**Committee of Experts on the Transport of Dangerous Goods
and on the Globally Harmonized System of Classification
and Labelling of Chemicals****Sub-Committee of Experts on the Transport of Dangerous Goods****Forty-fifth session**

**Recommendations made by the Sub-Committee on its forty-third,
forty-fourth and forty-fifth sessions and pending issues: miscellaneous pending issues****Appropriate hazard communication – lithium batteries and
Class 9****Transmitted by the expert from the United Kingdom¹****Introduction**

(No.9C)

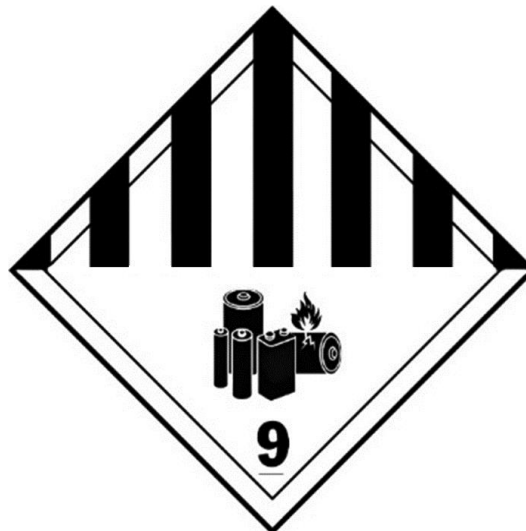
12. At 3.3.1, add a new Special Provision CCC, to read:

“The class 9 label to be used is No. 9C, see 5.2.2.2.2.”

13. At 5.2.2.2.2, under CLASS 9 Miscellaneous dangerous substances and articles, including environmentally hazardous substances, after the generic Class 9 label, add the following:

Symbol (seven vertical black stripes in upper half; battery group, one broken and emitting flame in lower half): black;

Background: white;

Figure “9” underlined in bottom corner’

“Lithium battery marks

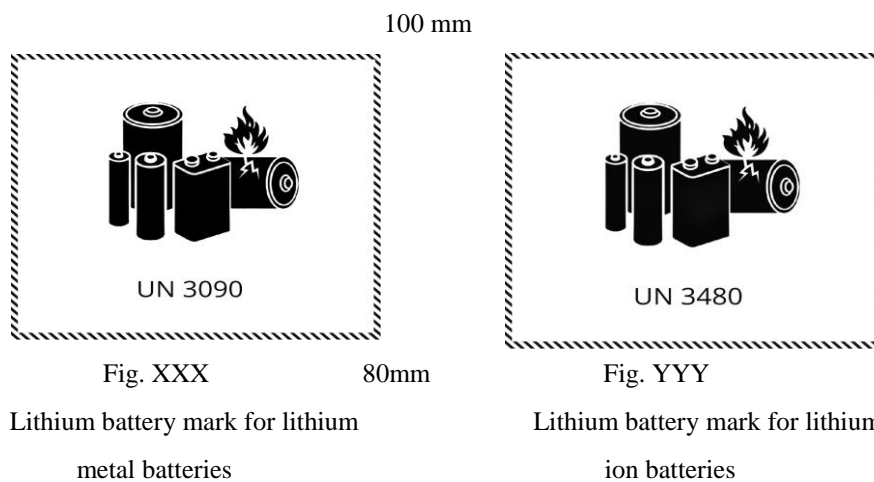
14. Insert new 5.2.1.9, to read as follows:

The lithium battery mark to be displayed in accordance with the special provisions of Chapter 3.3 shall be as shown in figures XXX and YYY for lithium metal and lithium ion batteries respectively. In cases of a mixed load of lithium metal and lithium ion batteries, both marks shall be displayed.

Where the lithium batteries are contained in, or packed with, equipment, ‘UN 3091’ or ‘UN 3481’ should be substituted for the UN numbers shown below. In cases of a mixed load of batteries and batteries in equipment, it is sufficient to display the battery label only.

The mark shall be in the form of a rectangle with hatched edging. The dimensions shall be [100mm x 80mm] and the minimum width of the hatching shall be 5mm. The symbol (group of batteries, one damaged and emitting flame, over the UN number for lithium ion or lithium metal batteries or cells) shall be black on white. The hatching shall be black. If the size of the package so requires, the dimensions/line thickness may be reduced, provided the marking remains clearly visible.’

(No.9G)

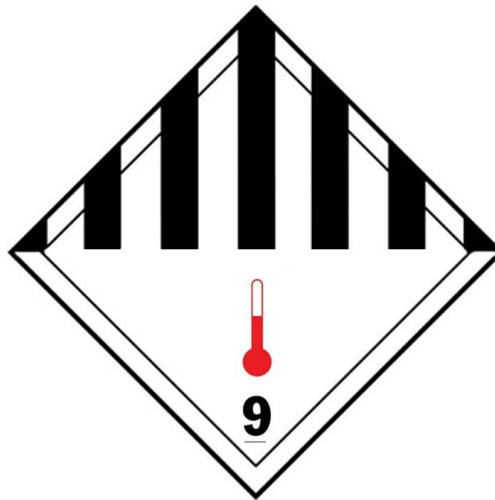
15. In the Dangerous Goods List in Chapter 3.2, add Special Provision GGG against the following UN numbers in column (6): 3257, 3258
16. At 3.3.1, add a new Special Provision GGG, to read:
- “Cargo transport units shall display the class 9 placard (No. 9G), see 5.2.2.2.2, in accordance with the provisions of Chapter 5.3. As an alternative, until [31 December 2019], the provisions of 5.3.2.2 may be used.”
17. At 5.2.2.2.2, under CLASS 9, after the generic Class 9 label, in alphabetical order with other labels, add the following:

Symbol (seven vertical stripes in upper half; black;
thermometer in lower half red);

Background: white;

Figure “9” underlined in bottom corner’

(No.9H)

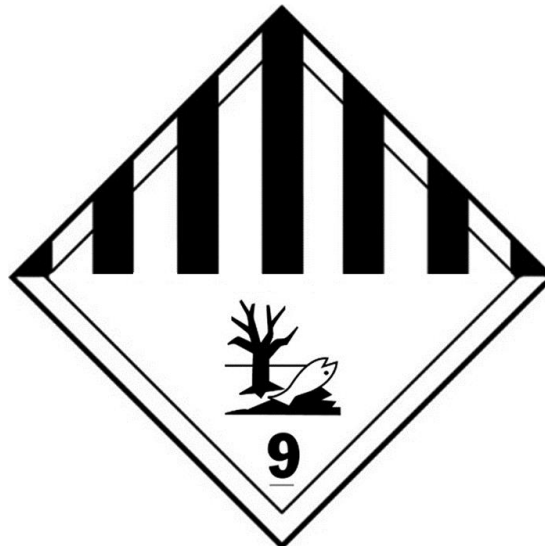
20. At 3.3.1, add a new Special Provision HHH, to read:

“The class 9 label to be used is No. 9H, see 5.2.2.2.2. As an alternative, until [31 December 2019], the provisions of 5.2.1.6 may be used.”

21. At 5.2.2.2.2, under CLASS 9, after the generic Class 9 label, in alphabetical order with other labels, add the following:

Symbol (seven vertical black stripes in upper half, fish and tree in lower half):
black; Background: white;

Figure “9” underlined in bottom corner’

(No. 9D)

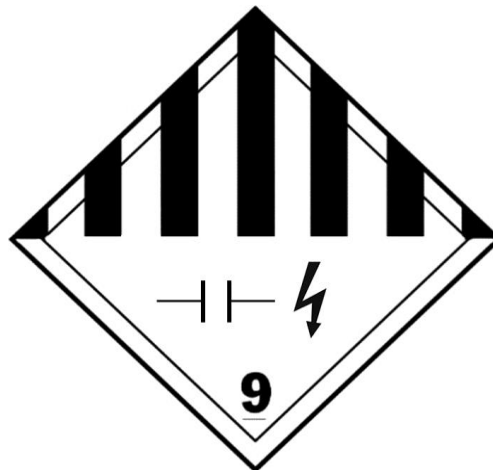
29. At 3.3.1, add a new Special Provision DDD, to read:

“The class 9 label to be used is No. 9D, see 5.2.2.2.2. As an alternative, until [31 December 2019], the generic class 9 label without the capacitor and/or electric shock symbols may be used.”

30. At 5.2.2.2.2, under CLASS 9, after the generic Class 9 label, in alphabetical order with other labels, add the following:

Symbol (seven vertical stripes in upper half); black;
(capacitor and/or electric shock symbols in lower half): black;

Background: white;

Figure “9” underlined in bottom corner’

(No. 9E)

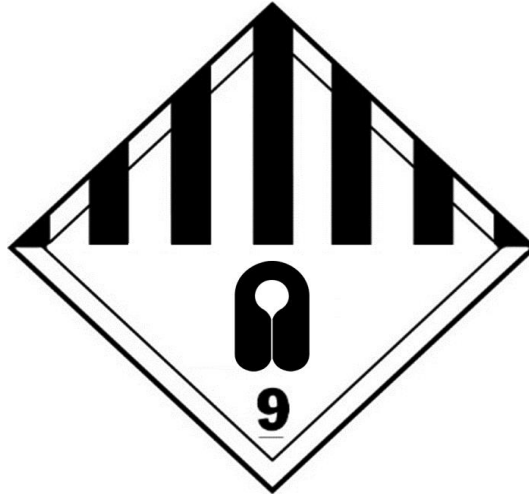
31. In the Dangerous Goods List in Chapter 3.2, add Special Provision EEE against the following UN numbers in column (6): 2990, 3072, 3268.
32. At 3.3.1, add a new Special Provision EEE, to read:
“The class 9 label to be used is No. 9E, see 5.2.2.2.2. As an alternative, until [31 December 2019], the generic class 9 label without the life vest symbol may be used.”
33. At 5.2.2.2.2, under CLASS 9, after the generic Class 9 label , add the following in alphabetical order with other labels:

Symbol (seven vertical stripes in upper half,
life vest symbol in lower half): black;
Background: white;
Figure “9” underlined in bottom corner’
[alternative:

(9I)

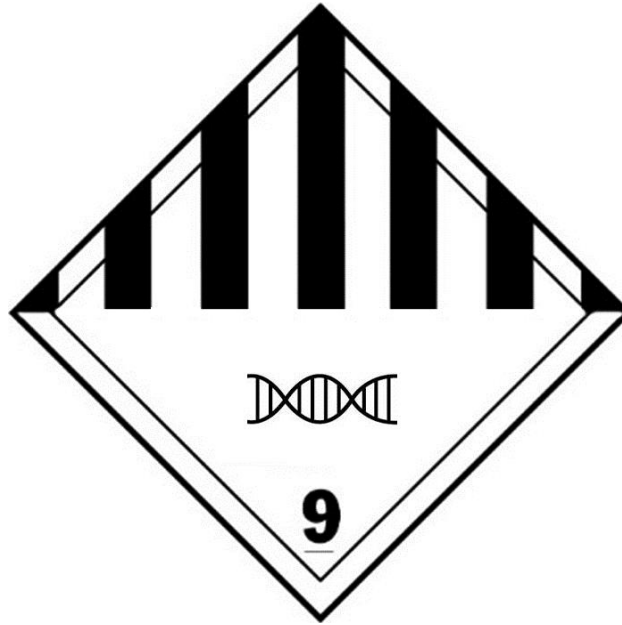
38. At 3.3.1, add a new Special Provision III, to read:

39. “The class 9 label to be used is No. 9I, see 5.2.2.2.2. As an alternative, until [31 December 2019], the generic class 9 label without the DNA double helix may be used.”

40. At 5.2.2.2.2, under CLASS 9, after the generic Class 9 label, in alphabetical order with other labels, add the following:

Symbol (seven vertical stripes in upper half,
DNA double helix in lower half): black;
Background: white;
Figure “9” underlined in bottom corner’
